**City of  
Richmond**

**Report to Development Permit Panel**

**Re:** **Application by Matthew Cheng Architect Inc. for a Development Variance Permit  
at 8480 No. 5 Road**

**1. DV 17-771661 (RESUBMISSION) - TWO-STOREY 1,308 S.M. BUDDHIST TEMPLE WITH HEIGHT VARIANCE FOR ROOF DESIGN**

Sheet  
**MAIN FLOOR PLAN**

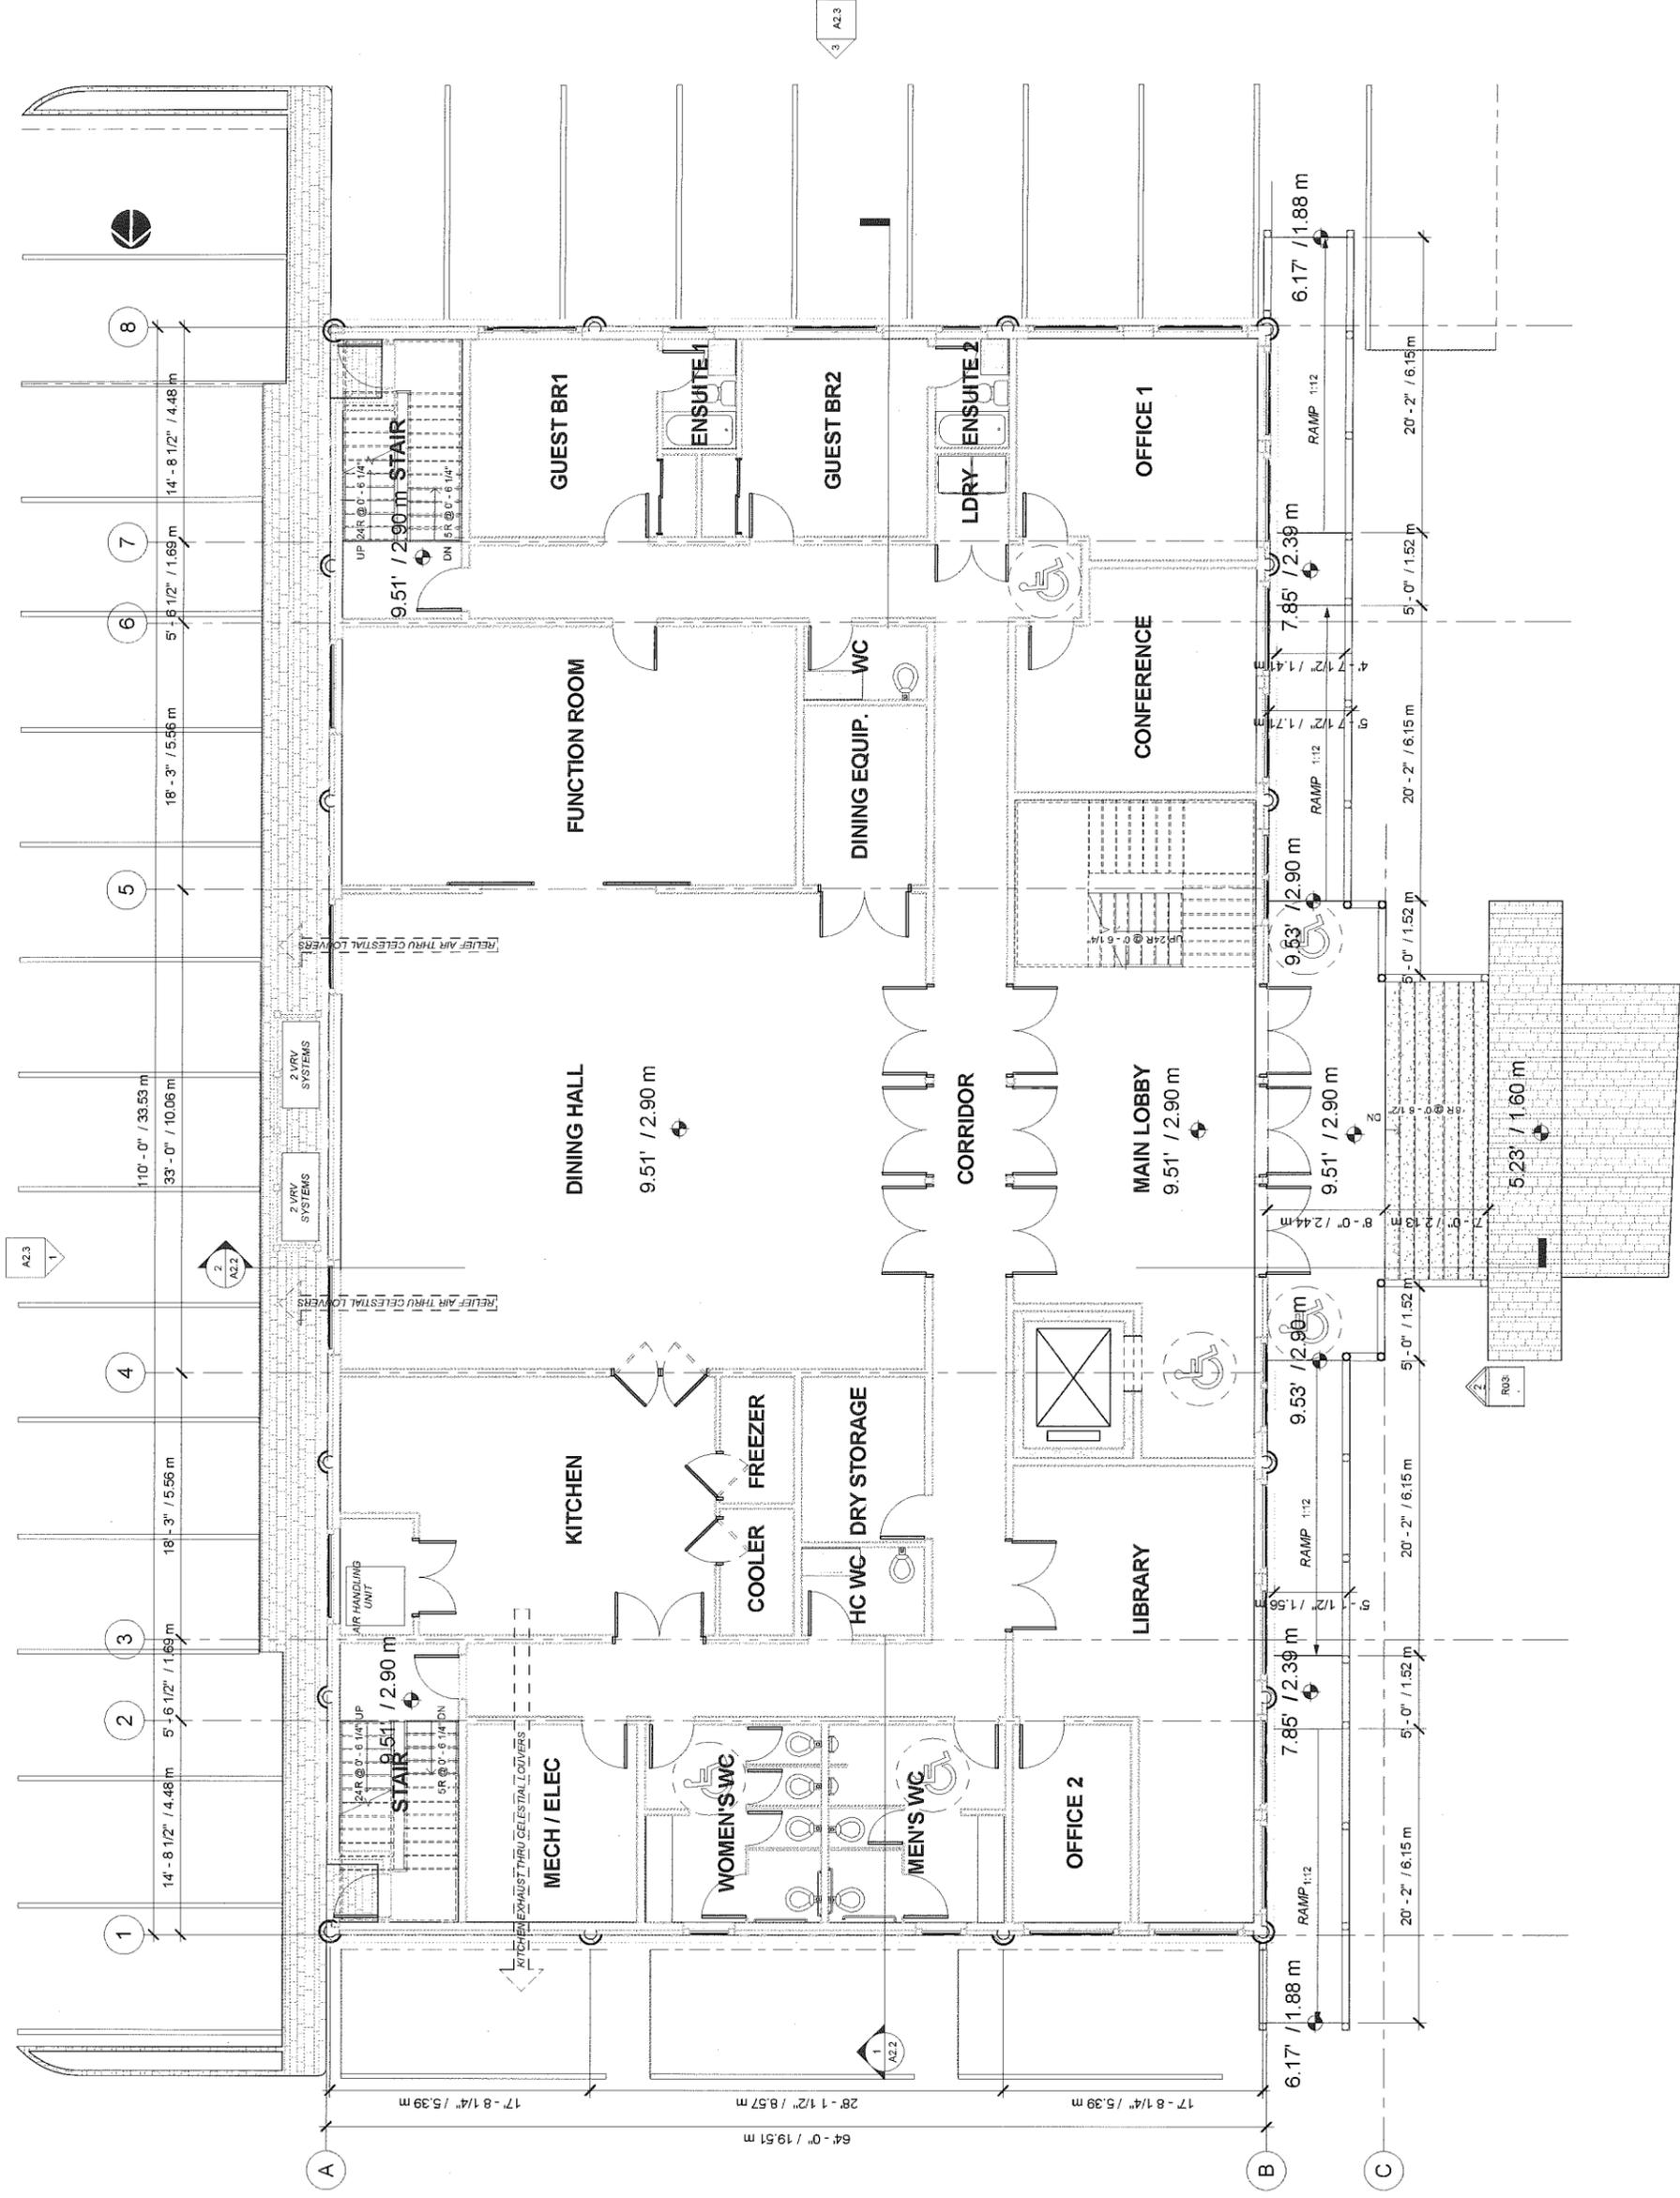
- consider increasing the width of the ramps up to the full width of the front entrance landing to provide adequate space for users, e.g. enable a user to pass by another user and allow users to walk side-by-side;

***Ramps are widen to 5'-7 ½" with 4'-7 ½" wide interior path clearance to accommodate two people walking side by side. Reference Page: Architectural 1/A1.0***

TYPICAL VENTILATION DETAIL AT  
CELESTORY OPENING  
1 1/2" = 1'-0"

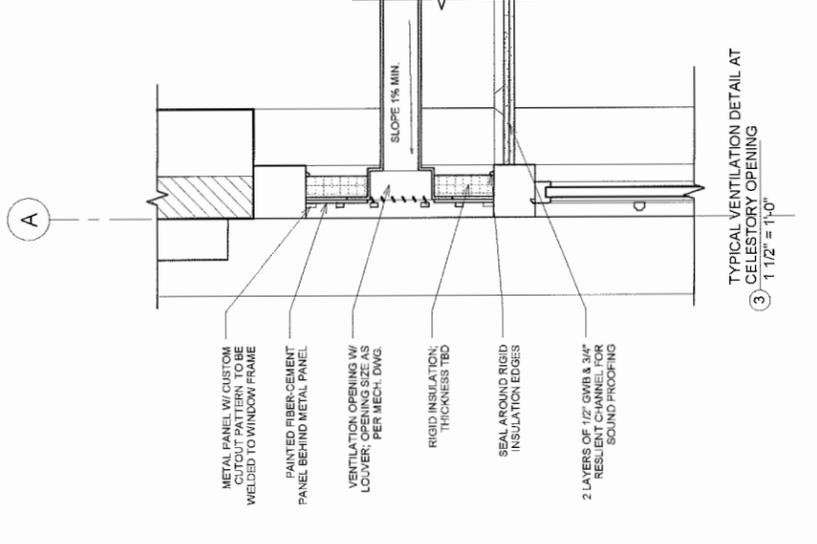
- appreciate the mechanical engineer for the project providing the Panel with mechanical plans, although not required at this stage of the project;
- mechanical and sustainability features for the project have not been integrated into the building's architecture; e.g. location of louvers indicated in the building's façade, but not integrated into the architecture of the building;

***Clerestory portion will be utilized for air intake/exhaust ventilation. Detail in larger scale is provided to illustrate the integration of architectural panel and mechanical ducting. Reference Page: Architectural 3 /A2.2***

DRAWING TITLE:  
**LANDSCAPE PLAN**

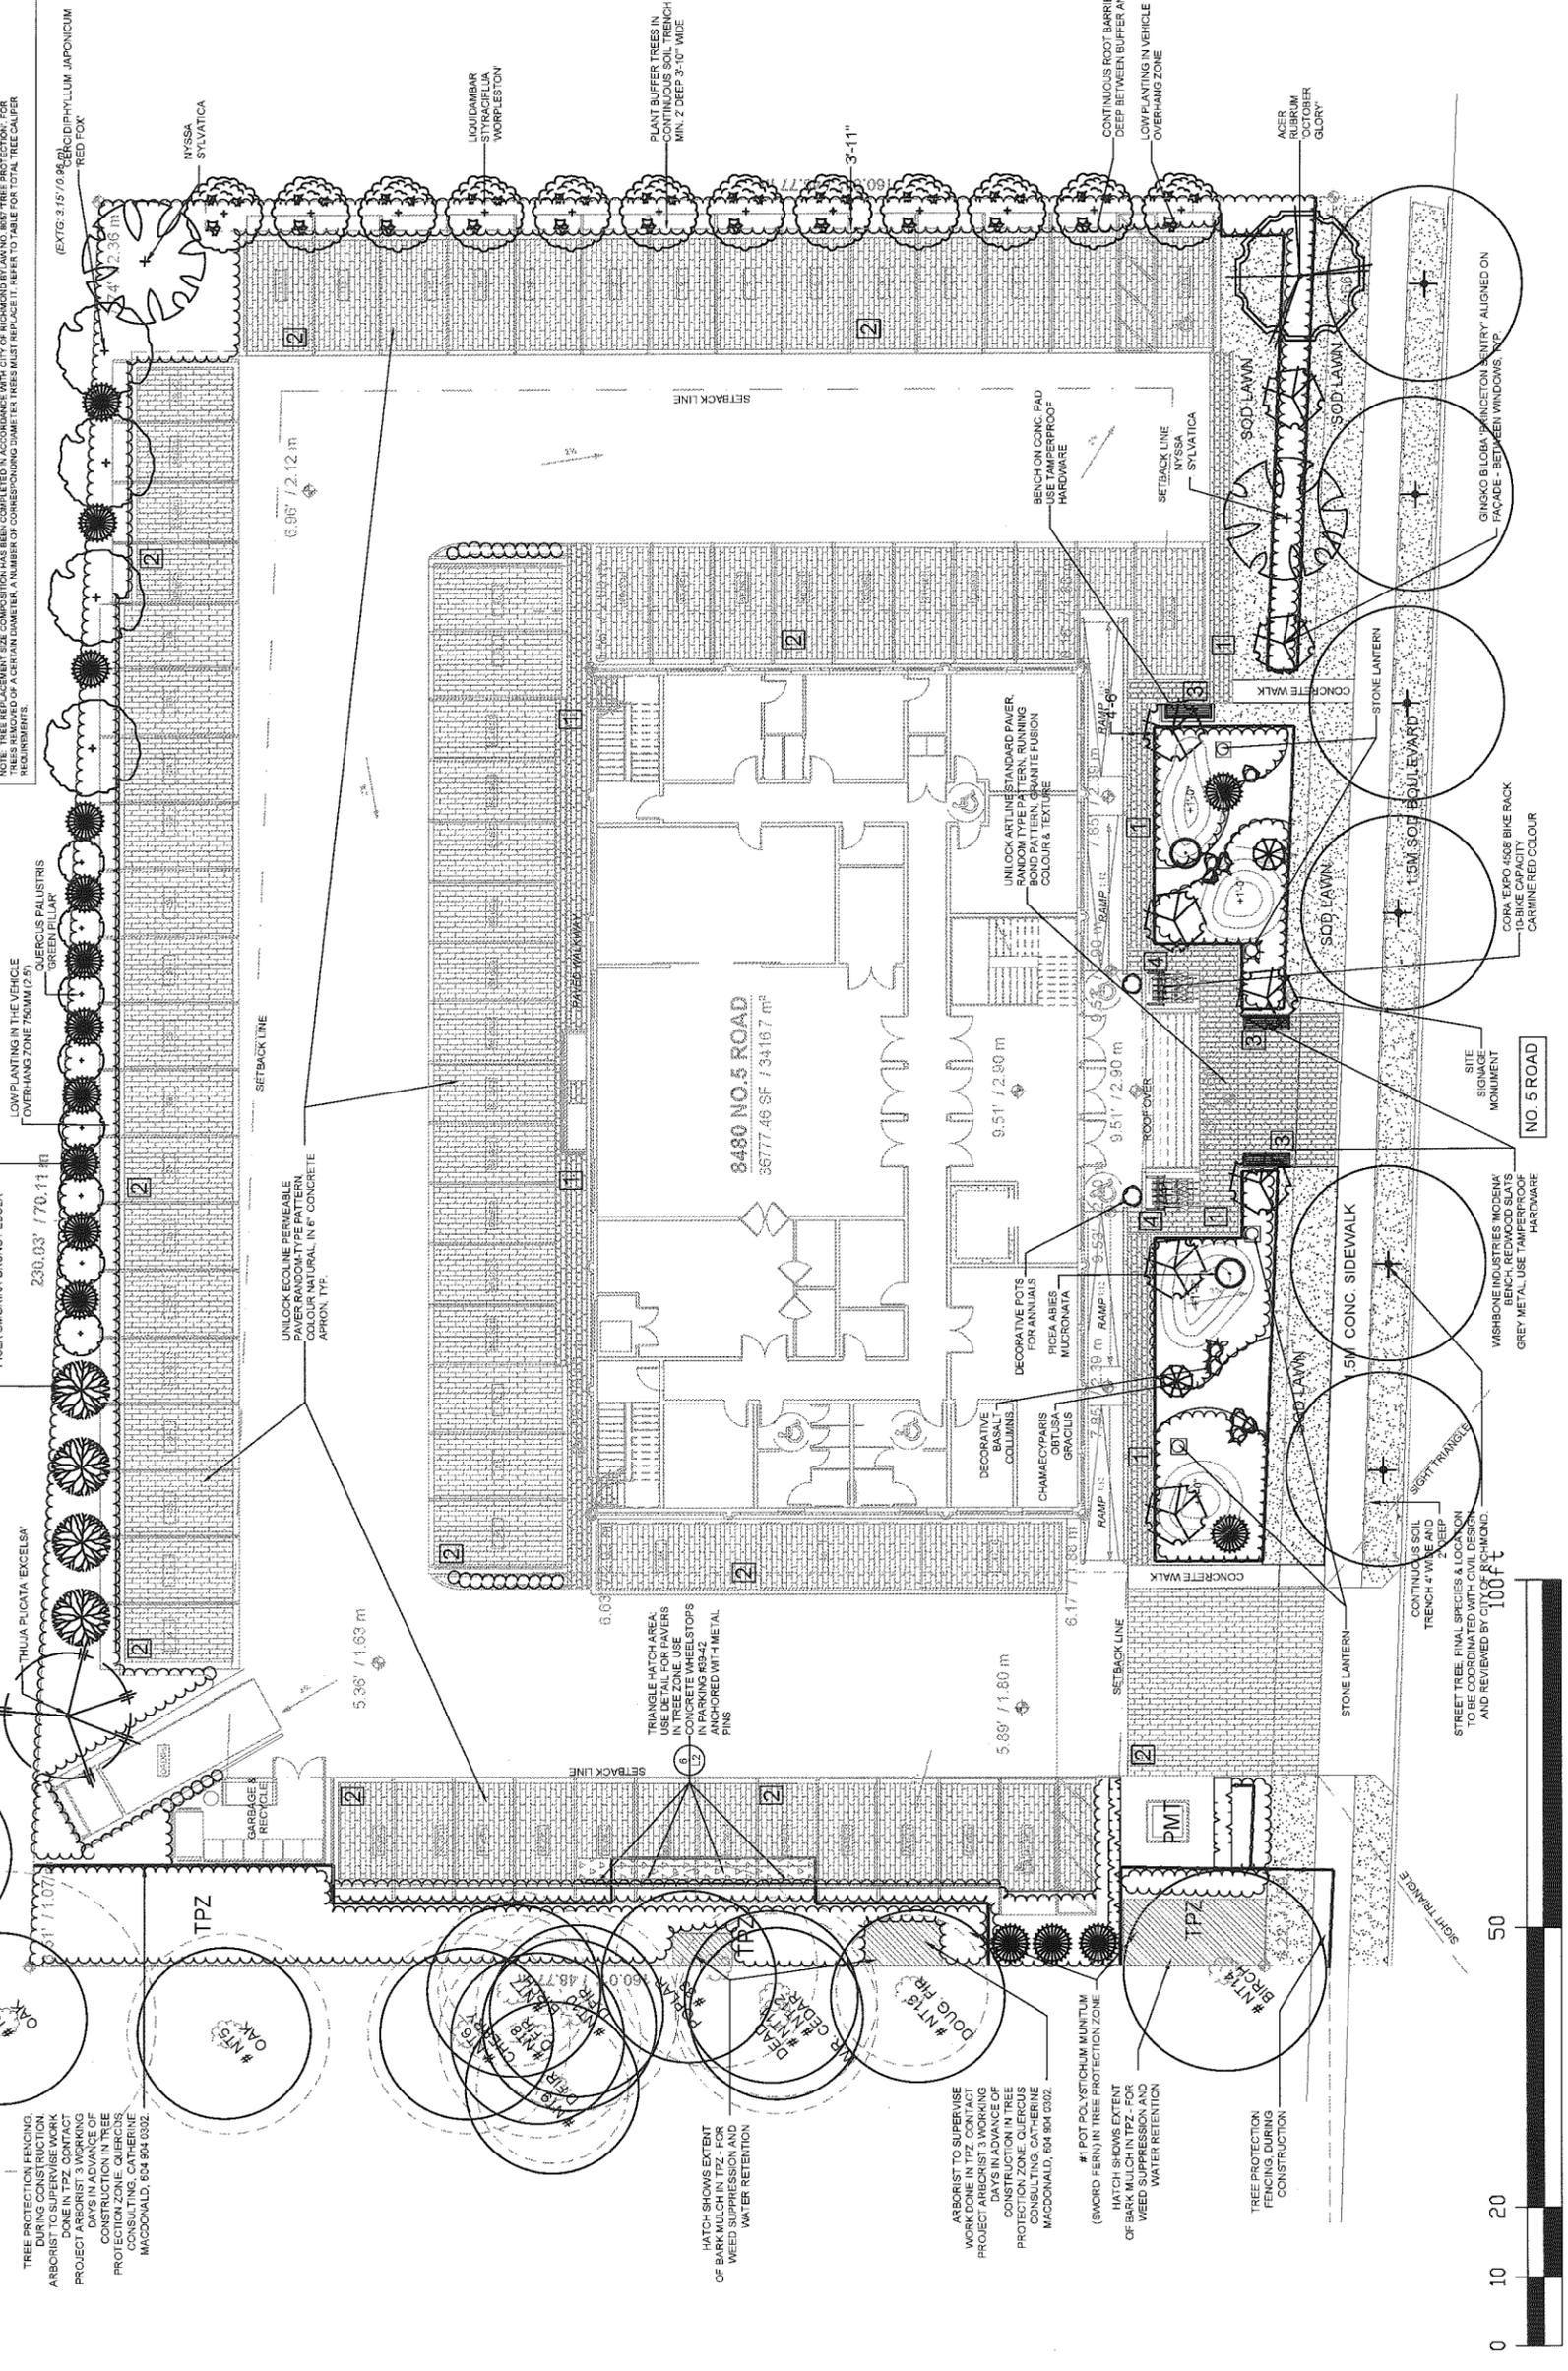
- support the building frontage sited adjacent to No. 5 Road as it will create opportunities for landscaping however, proposed landscaping needs clarity and design development, e.g. clarify whether the sod lawns fronting the building could be accessed by pedestrians;

***Revised landscape proposed a walkway around landscaping area for visitor to enjoying the landscape design. Reference Page: Landscape L1***

- proposed width and depth of the continuous soil trenches along the south property line would be inadequate due to size of trees to be planted and their proximity of the curb;

*Proposed soil trench is industry standard and shall provide adequate area for proposed trees to grow. Reference Page: Landscape L1*
